## Alternative Evaluations

## Illinois Accelerator Research Center (IARC) Building Functional Review

**Functional Review of Proposed Designs for IARC Building**  
**Report from the Review Committee**

**GROUND FLOOR**  
14,600 GSF  
EL 0.0

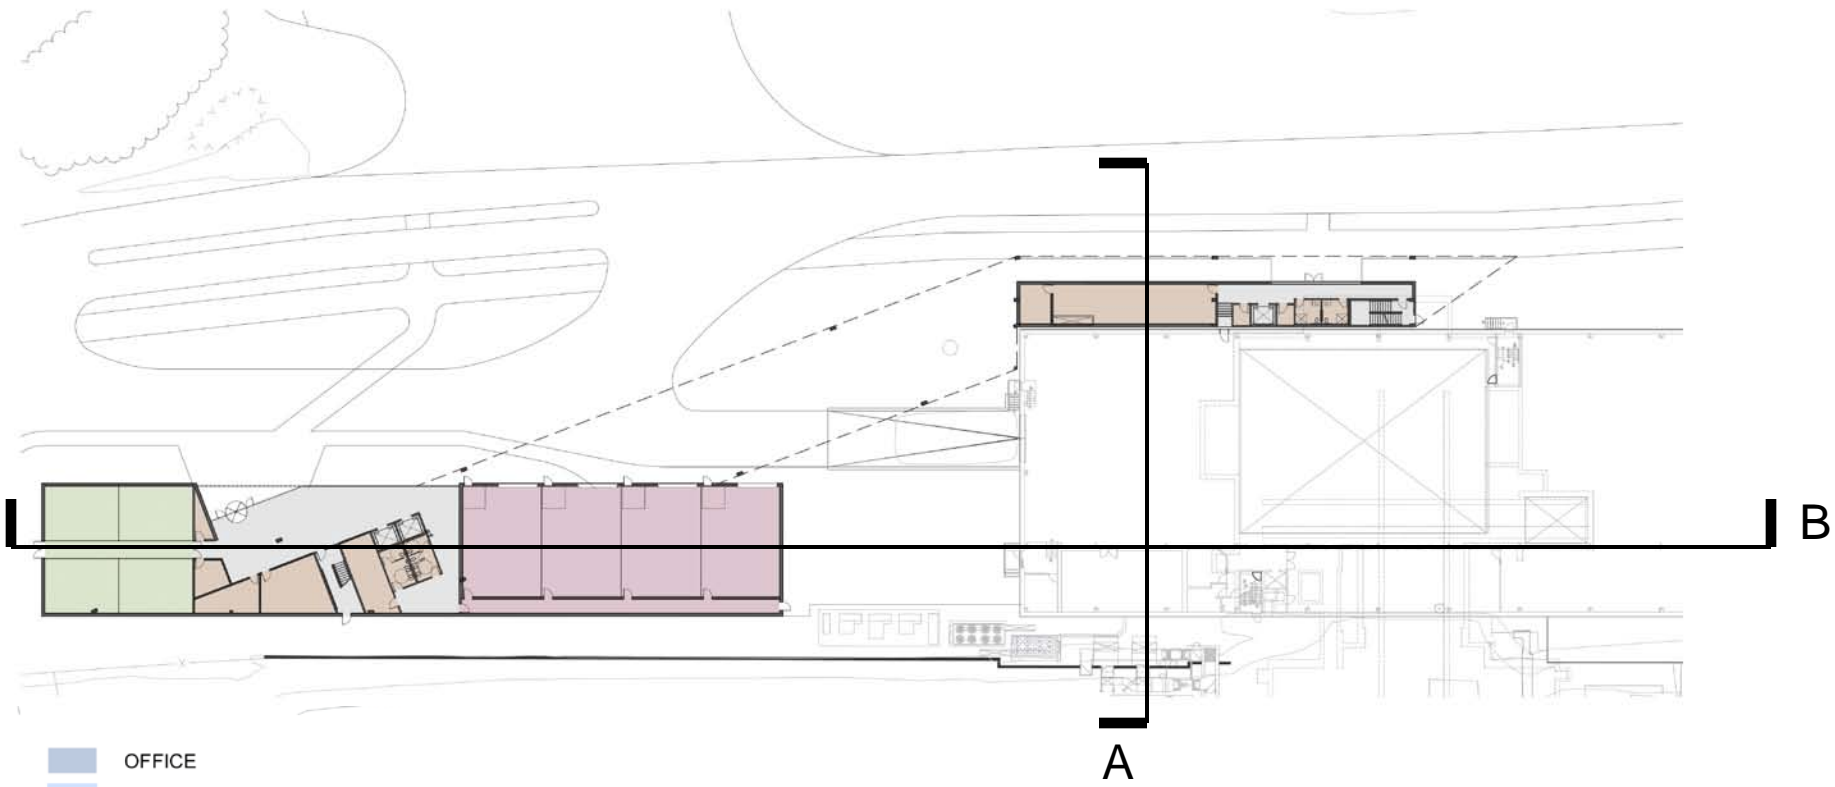
Both options appear to meet office requirements. Option A is more horizontally dispersed than Option B, and features a dead end on the wing that goes in front of CDF. The committee notes that in general communications are more effective between people on a single floor than on separated floors. We also note that Option A is less reliant on elevators to get from floor to floor. Based on these observations we believe that communication between building occupants would be fostered more in Option A than in B.

The 8' × 8' cubicles shown are industry standard, but this is less space than we are accustomed to at Fermilab (Fermilab standards are 9' × 10' cubicles and 10' × 12' offices within Wilson Hall). Option A appears to be less flexible than Option B in terms

of adapting to variable dimensions because of the non-parallel north and south walls. The committee wonders if Option A could be redesigned with a footprint that is a parallelogram rather than a trapezoid.

The committee notes that Option A has two entrances, whereas Option B has one. The committee felt that the extra entrance could be a plus, however the extra road crossing associated with this entrance is probably a minus.

**Recommendation: Provide some office space on the same floor as tech areas. The committee felt that only a few (~2) offices would be required.**
